Access Compliance Report

Public Rights-of-Way

(Curb Ramps)

Intersection ID: 29178	Main Street: HARRIS_CENTER_DR	Cross Street: STATESVILLE_RD	Location: SE
ADA ID: DA05AC684795	Ramp Type: Perp	Initial Pass/Fail: Fail	Overall Compliance: No
Severity Score: 12.5			
Codes/Mitigation Info/Possible Solution		Field Measurements/Component Compliance

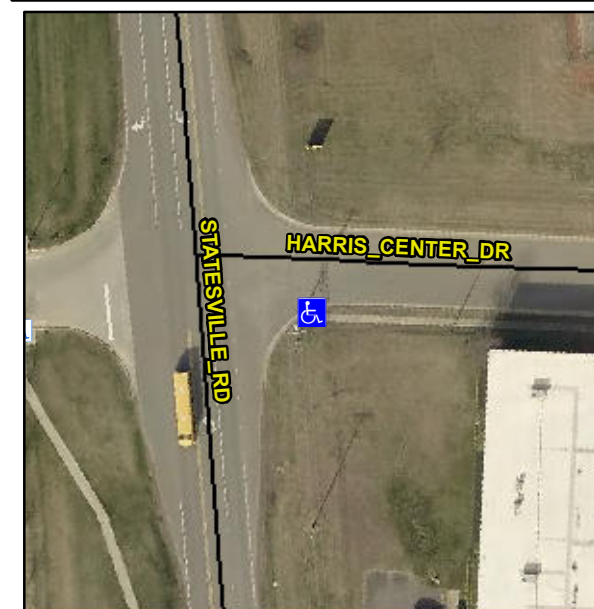
Not Found, R304.2.2

Compliance	Description	Data	Compliance	Description	Data
N/A	Ramp Length (in)	37.0	No	Ramp Slope (%)	9.9
Yes	Ramp Width (in)	49.0	Yes	Ramp XSlope (%)	1.1
N/A	Flare Type LT	N/A	N/A	Flare Type RT	N/A
N/A	Flare Slope LT (%)	N/A	N/A	Flare Slope RT (%)	N/A
N/A	Flare Traversable LT?	N/A	N/A	Flare Traversable RT?	N/A
N/A	Landing Length (in)	N/A	N/A	DWS Provided?	N/A
N/A	Landing Width (in)	N/A	N/A	DWS Contrast?	N/A
N/A	Landing Slope (%)	N/A	N/A	DWS Length (in)	N/A
N/A	Landing X Slope (%)	N/A	N/A	DWS Full Width?	N/A
N/A	Landing Curb? (Y/N)	N/A	N/A	DWS Offset (in)	N/A
N/A	Shared Landing?	N/A			
N/A	Gutter Ponding?	N/A	N/A	Gutter Slope (%)	N/A
N/A	Gutter Lip Ht (in)	N/A	N/A	Gutter X Slope (%)	N/A
N/A	Painted X Walk1?	No	N/A	Painted X Walk2?	N/A
	X Walk 1 Direction	To N		X Walk 2 Direction	N/A
N/A	X Walk 1 Width (in)	N/A	N/A	X Walk 2 Width (in)	N/A
	X Walk 1 Slope (%)	0.5		X Walk 2 Slope (%)	N/A
	X Walk 1 X Slope (%)	1.6		X Walk 2 X Slope (%)	N/A

Remove & Replace Entire Ramp.
